G. N. R. R.  
PLAN SHOWING STANDARDWOOD FILLERS - END POST, SHOE ANGLE  
WITH PLATE, STEEL STRAP & FIBRE SHOE ANGLEFOR APPLYING  
WEBER NO. 1 INSULATED RAIL JOINTS

ON 60 LB., 68 LB. & 75 LB. RAIL SECTIONS  
OFFICE OF SIGNAL ENGINEER ST. PAUL MINN.

167-32-C.

Fig.3. Iron Shoe (See Section Below)  
& Note 2

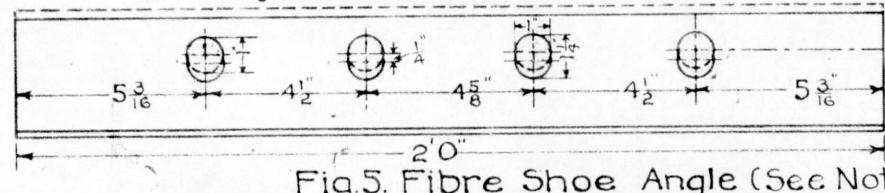
Note 2: The change in iron shoe 167-32-B Fig.F consists of drilling holes as shown by Fig.3 and section and riveting on a  $\frac{1}{4}'' \times 6'' \times 2'0''$  iron plate.

Fig.5. Fibre Shoe Angle (See Note 3)

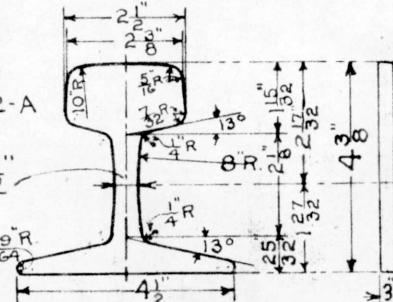
Note 3: The change in fibre shoe angle 167-32-B. Fig.B. consists of cutting  $\frac{1}{4}$ " off top of fibre and making the holes  $\frac{1}{4}$ " lower as shown by Fig.4.

Fig.6. Fibre End Post.  
(See Note 4)

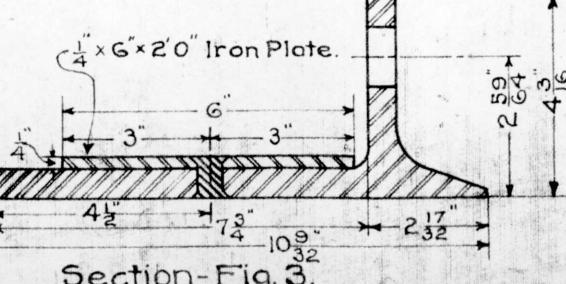
NOTE 'A'. REVISED OCT. 3, 1919 -  
THICKNESS OF END POST CHANGED  
FROM  $3\frac{1}{16}$ " TO  $3\frac{1}{8}$ ".

Note 4: When fibre end post Fig.6. is used on 60LB. Rail  $\frac{1}{8}$ " must be cut off top making it  $4\frac{1}{4}$ " in height.
